ZONING CHANGE REVIEW SHEETCASE: C814-2008-0136.02DISTRICT: 7

(North Austin Medical Centre Planned Unit Development Amendment #2)

Staff recommends the 2nd amendment to the North Austin Medical Centre PUD, with redlined notations on the PUD Ordinance No. 20100624-109 and the accompanying land use plan (Exhibit D), to permit changes to water quality requirements, involving drainage and detention within the PUD.

EXHIBIT B - Proposed Plan

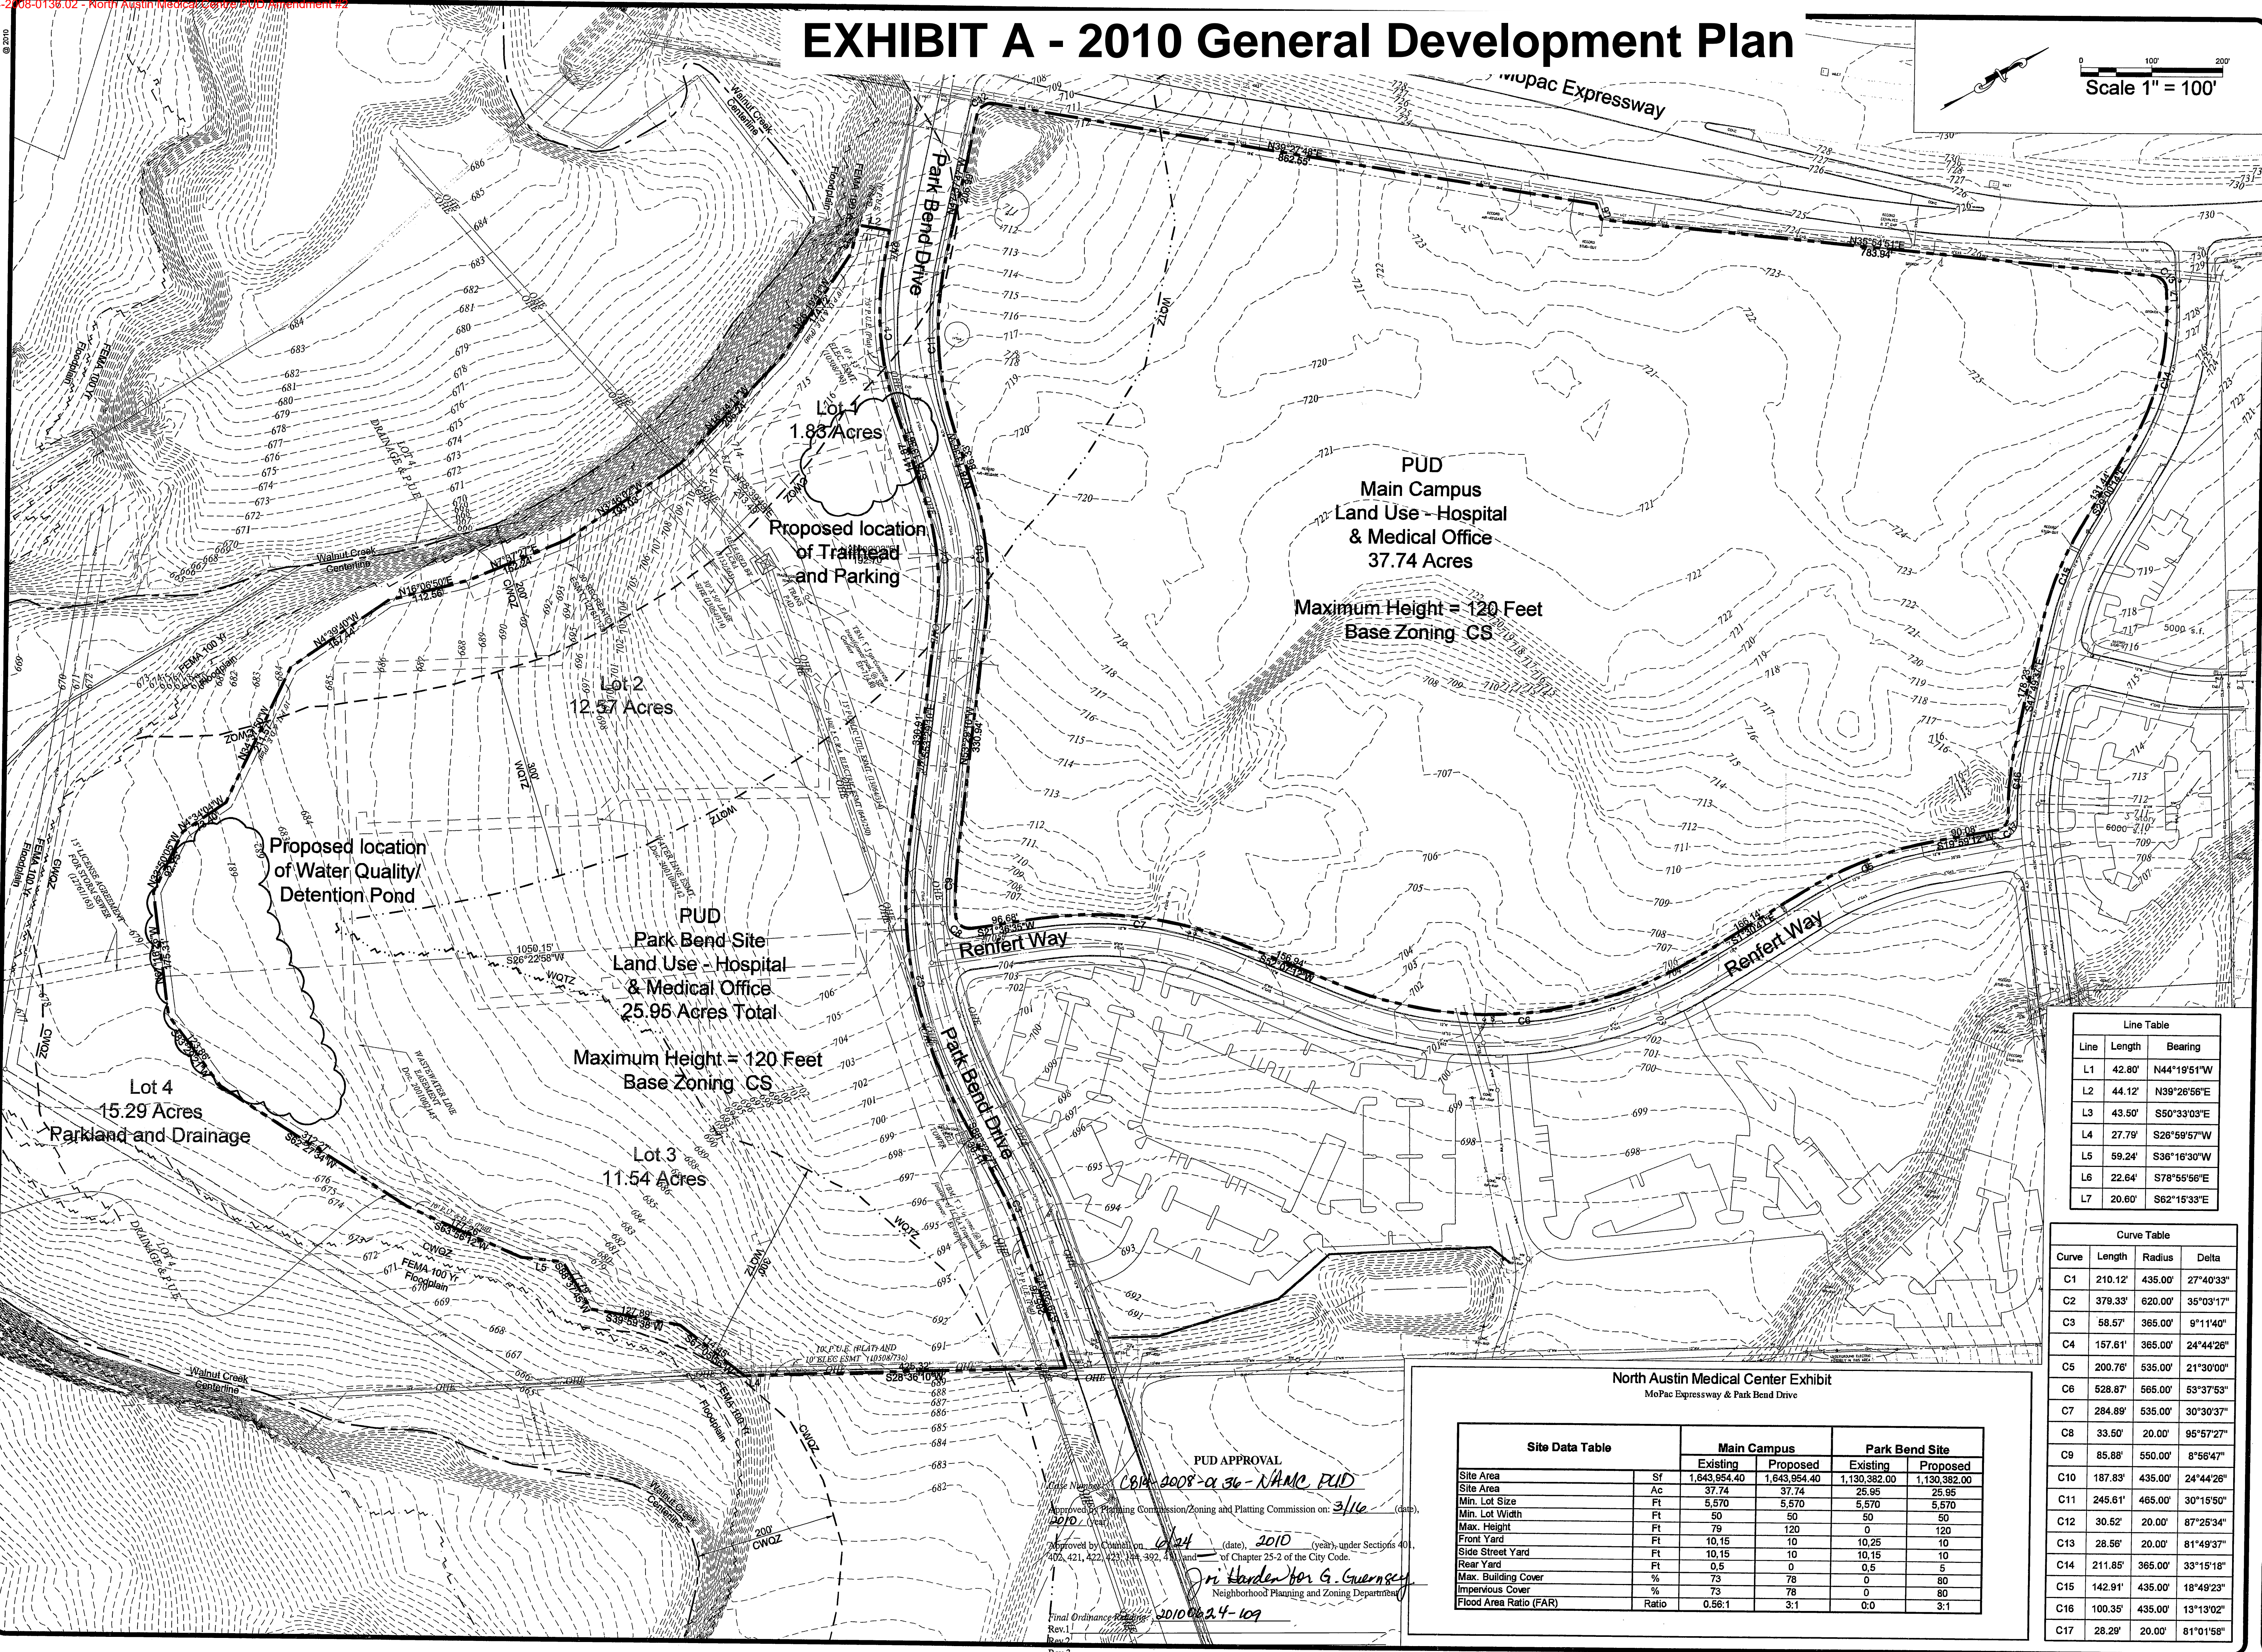
Be sure that the WQTZ and CWQZ creek buffers are shown, labeled, and included in the legend on Exhibit B – Proposed Plan (aka Ex 1 – Option 2 Exhibit). Comments related to uses permitted in the creek buffers is pending.

U1 Comment pending. The WQTZ should be a consistent 300-foot offset from the CWQZ. Please note that per the code of 2008 only water quality controls (no detention) may be in the WQTZ.

On Exhibit B, some things are labeled “existing” and others “proposed.” Clarify what these terms mean in the context of this PUD.

U1 Comment pending. Only water quality controls are allowed in the WQTZ.

EO1 Update1: Please label CWQZ, CEF/CEF setbacks and location of creek center line on Exhibit B.

EO3 Update1: Provide an exhibit showing the original 21.55 acres of drainage area intended for water quality treatment by the approved pond configuration. In the exhibit, clarify how the approved 21.55 acres of drainage area differs from the proposed 13.65 areas of drainage area using different colors or hatching to differentiate between the two areas.

Response: Critical Water Quality Zone (CWQZ), Critical Environmental Feature (CEF) and Walnut Creek lines and setbacks are shown and labeled. CWQZ and WQTZ comply with 2008 regulations and are defined by PUD Ordinance No. 20100624-109, Exhibit B: Land Use Plan.

Response: Separate exhibits and an overlay have been prepared and attached with this submittal for review.
